Enquiries: Neil Beck
Our Ref: OP 2023_5560/1 (1204830)
Your Ref: ARO0188

CONFIRMATION NOTICE & INFORMATION REQUEST

Application Number: OP2023_5560/1
Approval Sought: Development Permit
Nature of Development Proposed: Operational Works
Description of the Development Proposed: Operational Works (Earthworks)

Image 2 Qld Globe August 2023 – spoil piles along northern boundary of site and appearing to extend east into drainage path lot

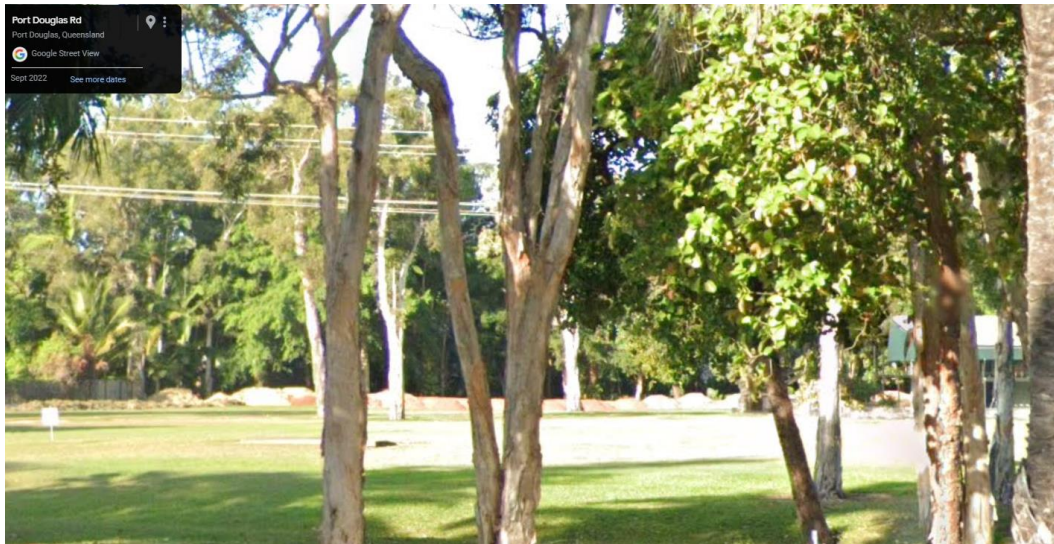
Observations from Port Douglas Road (and verified by Aerial Images from 2022 and 2023) indicate that spoil has been progressively deposited on the site for a period exceeding 12 months. Refer Images 1 to 3 below.

The images also indicate differing soil types as observed in the colouring of the spoil mounds suggesting varying fill sources. Concern also raised with the works extending into the adjoining drainage path allotment.

Image 1 Qld Globe Sept 2022 – spoil piles in east and northeast of site

Image 3 Google Street View – Sept 2022 – spoil piles along eastern side of property

2. The applicant is requested to confirm the maximum length of time that the exposed spoil piles will be on site before controlled filling and placement will be undertaken in accordance with FNQROC Development Manual specifications.

In the event that this period of time is greater than three months, the applicant is required to determine the size of stages of the works where filling can be completed and the area final trimmed and revegetated within a three-month window.
